### DIAGRAMMATIC CROSS SECTION BY MR. C. L. CANARD

## REVIEW OF DIAGRAMMATIC CROSS SECTION BY C. L. CANARD

ENCLOSURE B

WORK COPY  
SEPTEMBER 26, 1986  
C.L. CANARD

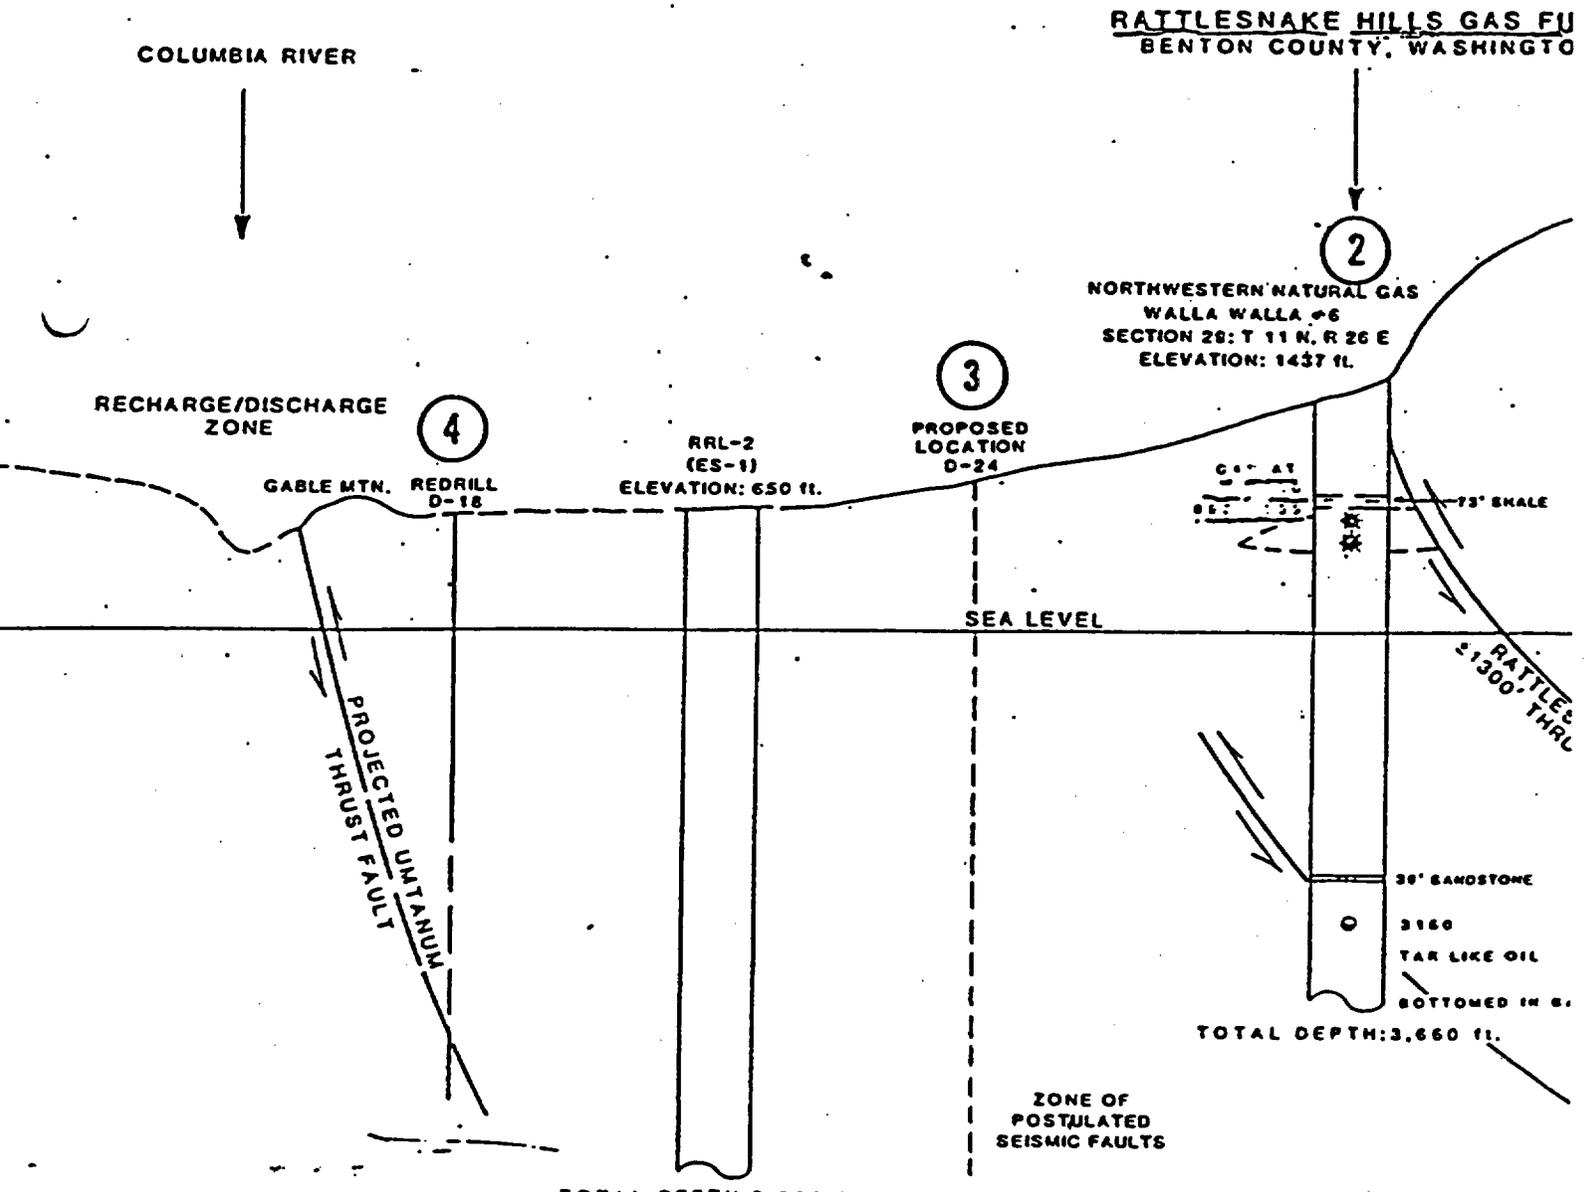
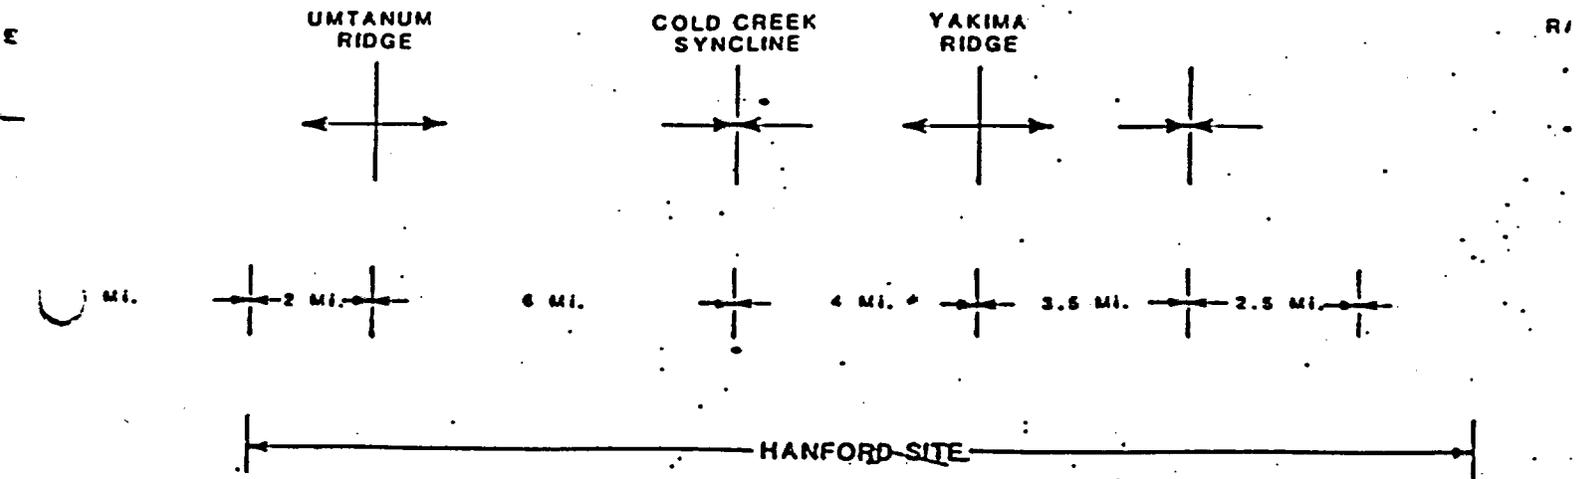
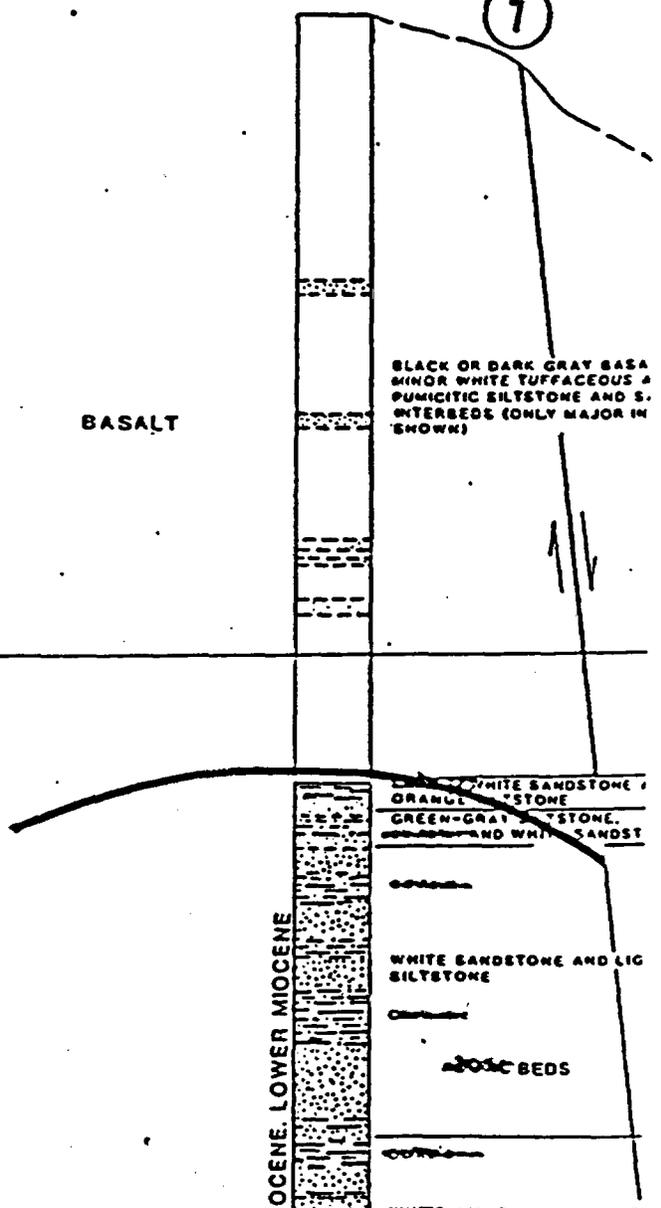
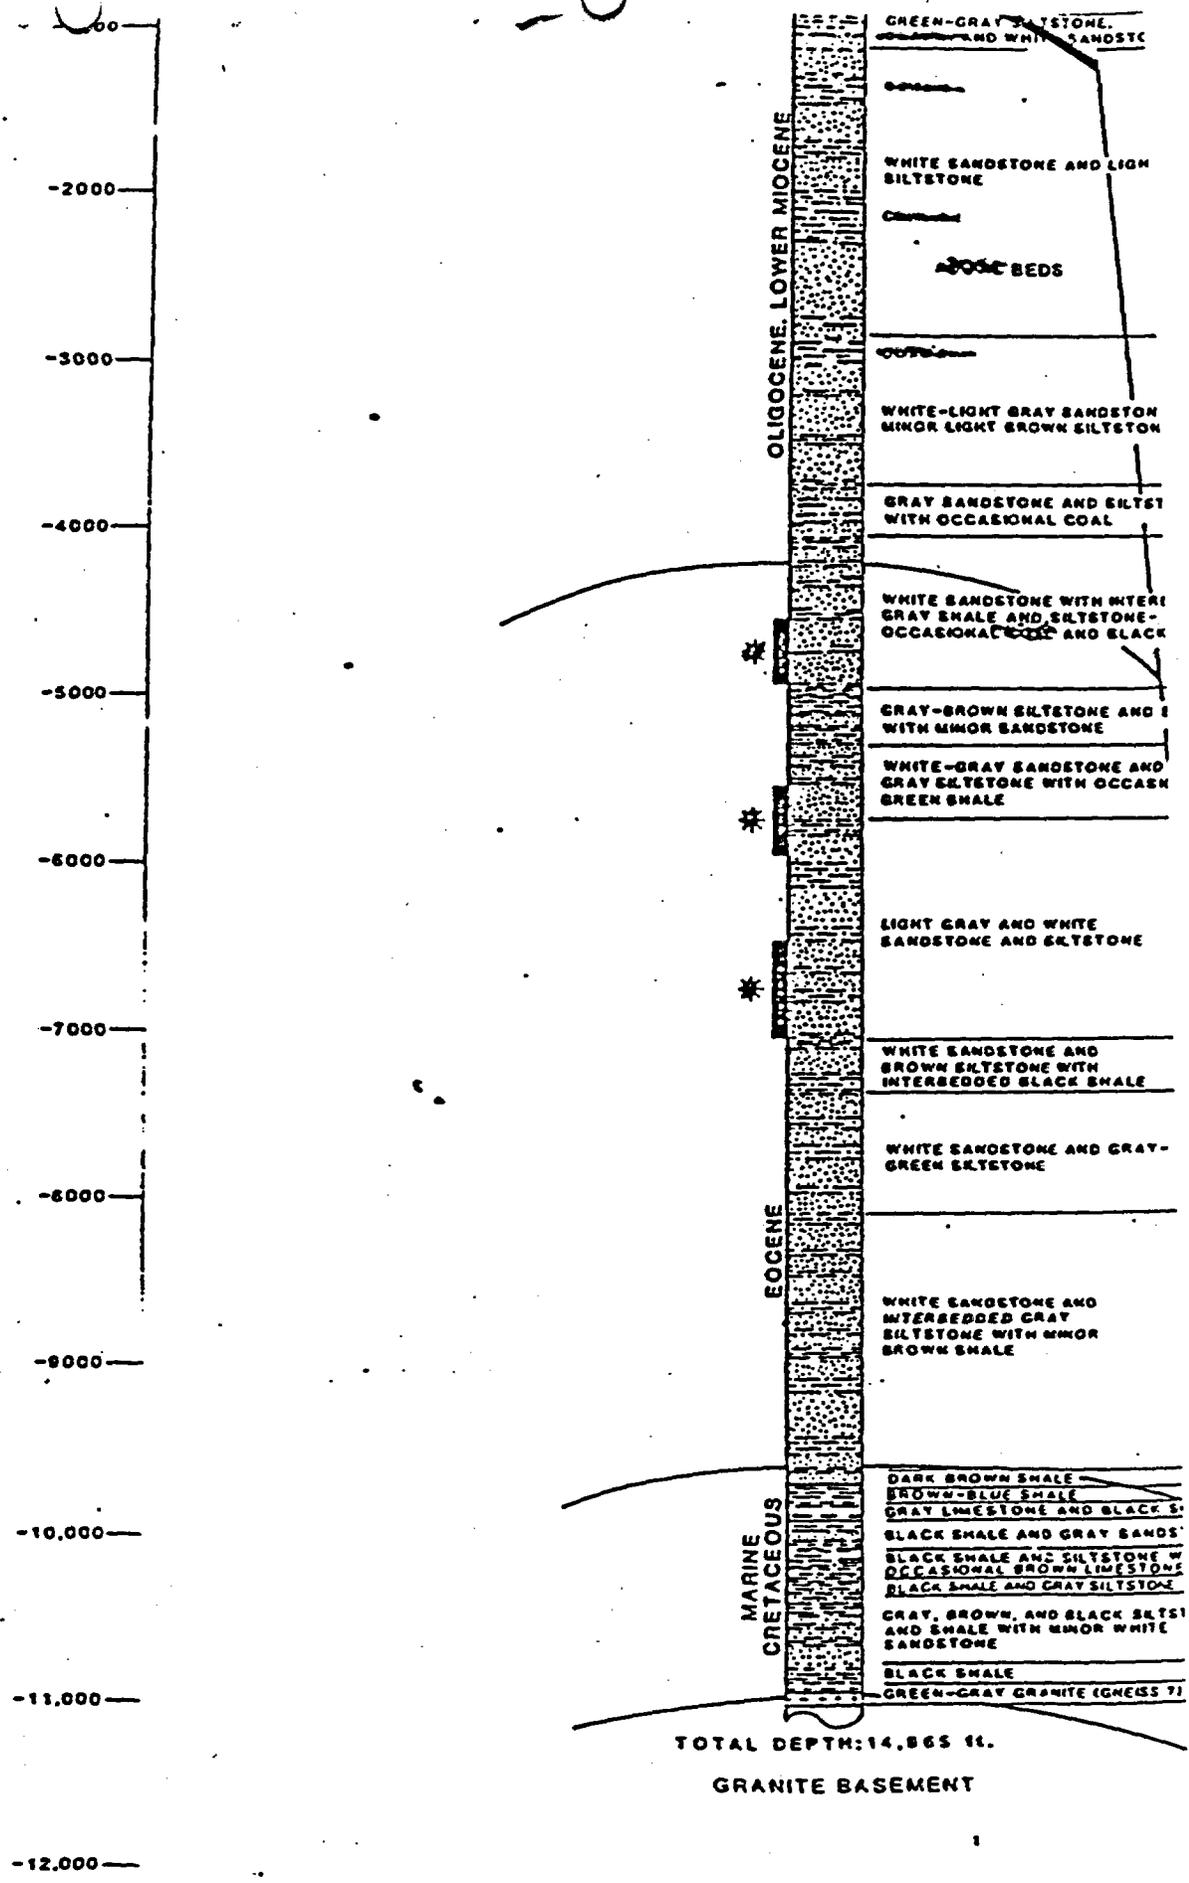
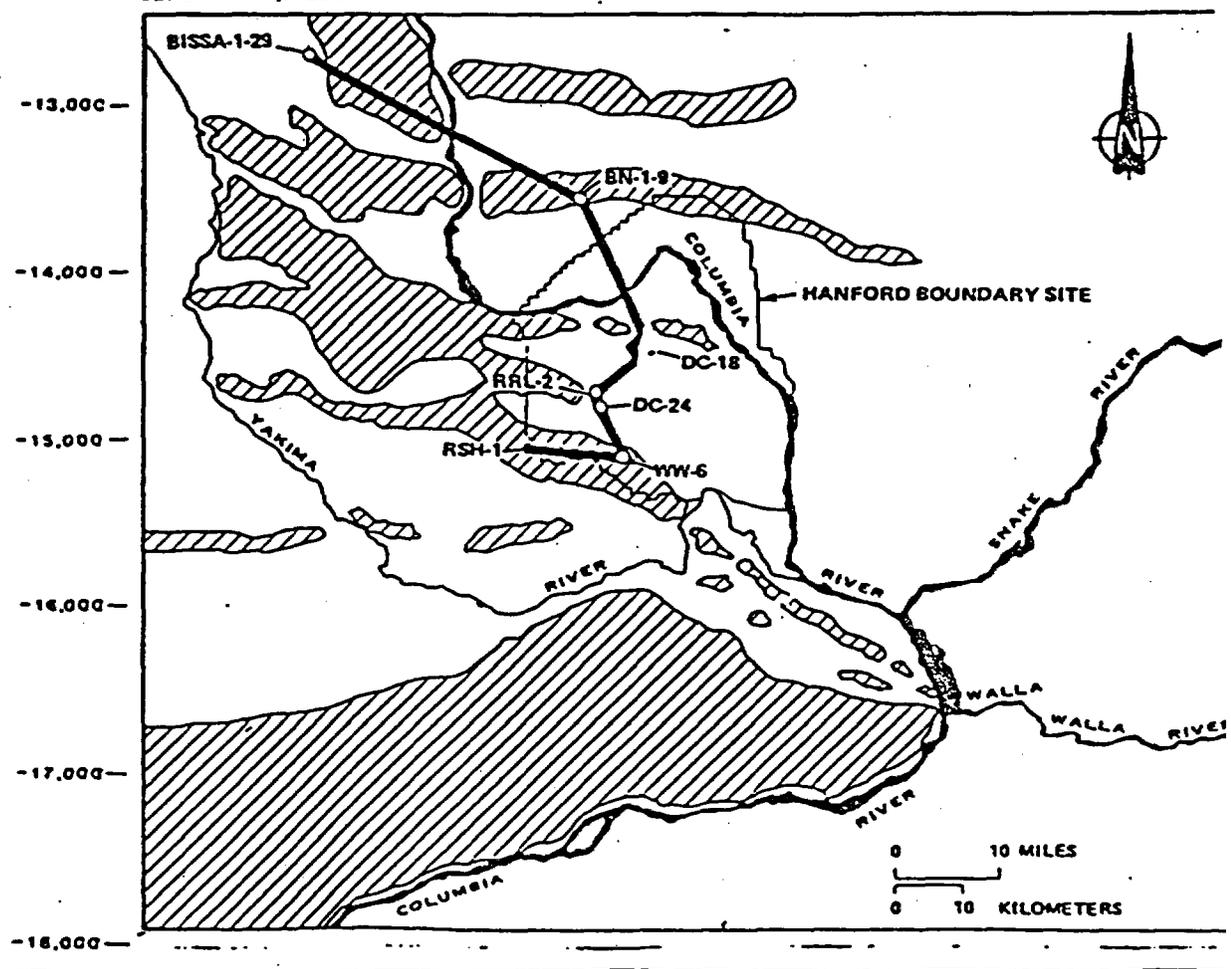
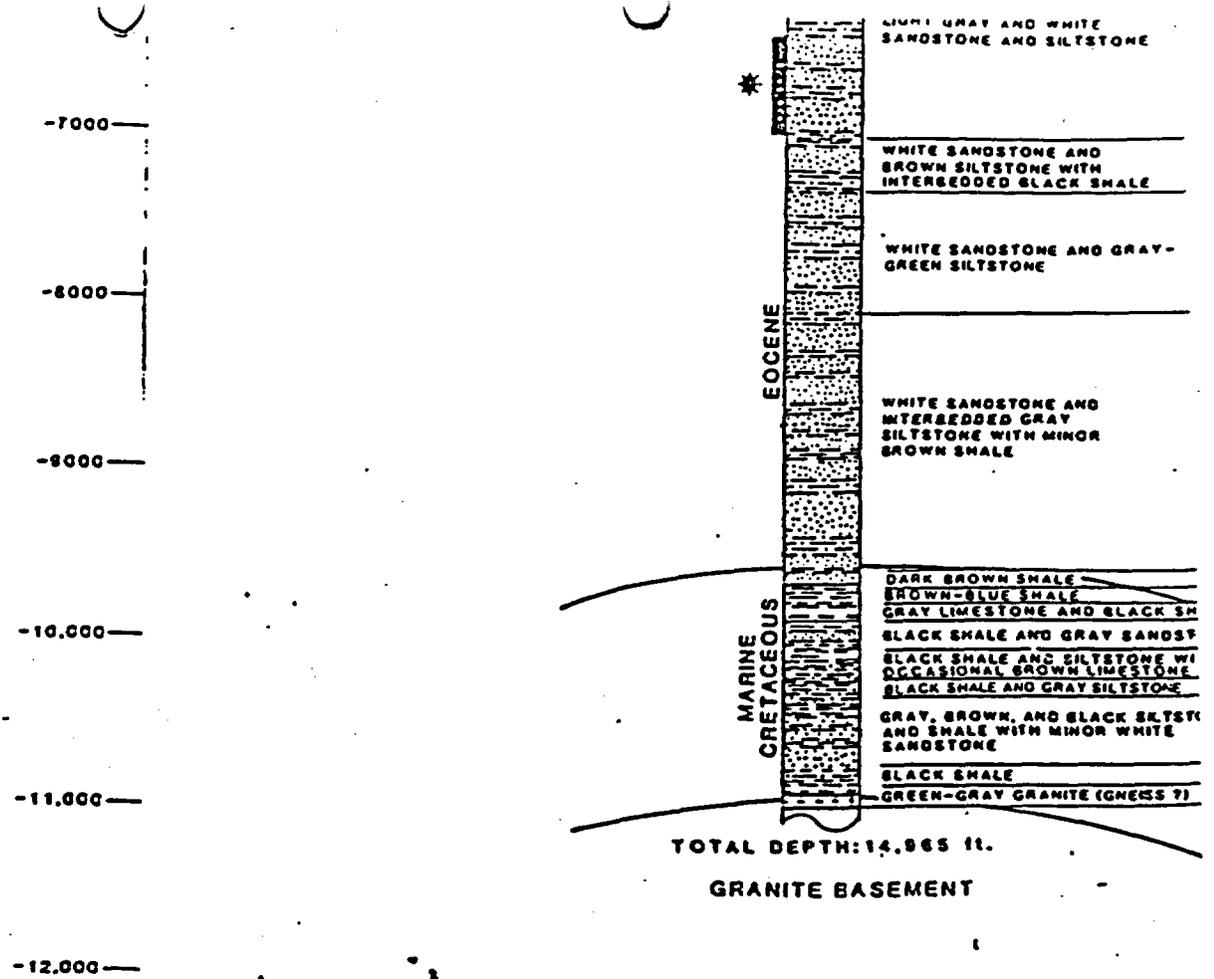
Rockwell: the interpretation of thrust faulting is questionable; the use of dipmeter data on basalt flows is questionable and the dipmeter data shown does not agree with the fault projection shown.

Rockwell: no evidence of faulting in driller's log.

Rockwell: "no present geologic evidence of faulting at this location."

Rockwell: projection of the Umtanum thrust fault into the undrilled section of DC-18 and projection of the Saddle Mountains fault on the north flank of Saddle Mountain are conjectural.

Rockwell: no data referenced to establish such a fault zone; projection of the fault beneath DC-18 is conjectural.

Rockwell: a fault with minor strike-slip displacement at about this location has been mapped.

Rockwell: published maps show faulting with 50-100 feet displacement in the area.

Comment: Pollen correlations and coal bed stratigraphy, as described by Newman in the Raymond and Tillson (1986) report, are not well established. Newman's conclusion that the pollen may be Oligocene in age is based on negative evidence -- lack of the Miocene pollen species *Compositae* in the assemblage was interpreted by Newman as evidence of a pre-Miocene age. Later, Barnett and Fisk (1980) reported a pollen assemblage in the Vantage interbed of CRB which also lacks *Compositae*; however, the Vantage interbed has an established middle Miocene age. Therefore, if the primary basis for an imbricate thrust fault interpretation is on duplication of Oligocene beds, then the interpretation is questionable. Furthermore, if the dipmeter data of 20-24° is used and the faulting projected northward at a 1:1 scale (rather than 15:1), faulting would project to the surface approximately six to seven miles south of WW-6. At true scale, the fault plane in RSH-1 would have to dip on the order of 3° to reach the WW-6. Dipmeter data in basalt flows can be misleading if levels of calculations are in joint or fracture plane zones and not on bedding plane contacts.

Comment: The available data on WW-6, which consists of a drillers log only, have been reviewed. The log makes no reference to faulting at any depth in the well, and there are no indicated zones such as fractured rock or breccia which could be interpreted as fault zones.

Comment: There is no present geologic evidence of faulting at this location, but earthquakes indicate some rupture and slip on geologically unmapped faults is occurring. These faults could be very limited in extent and displacement. The presence of "blind thrusts" is not supported by focal mechanism solutions of earthquakes in the basalt and below. Solutions at varying depths indicate steeply dipping reverse faults on nearly east-west planes.

Comment: Projection of the Umtanum thrust fault into the undrilled section of the borehole is conjectural. In addition, projection of the Saddle Mountains fault on the north flank of the Saddle Mountains is also conjectural. The BWIP gravity data does not support a significant fault displacement at depth at this location. Breccia zones have been logged in the boring between 1,204 feet and 1,302 feet (3 zones), but as yet no interpretation has been made on possible fault geometry.

Comment: No data are referenced to establish the fault zone in the well section nor the displacement to the south of the well location. Grolier and Bingham (1972) and Reidel (1984) have published mapping of the area and have indicated a south dipping fault, 45° or steeper. As previously discussed in Item 4, projection of the fault and its displacement to the south beneath borehole DC-18 is conjectural.

Comment: The fault may be part of a larger fault mapped as the Sagebrush Springs fault and shown on Tolan (1986).

Comment: Mapped faulting in this area (Tolan, 1986) shows north-south faulting with relatively small displacement on the order of 50-100 feet. There is no present surface or subsurface information that would support the interpretation of large displacement.
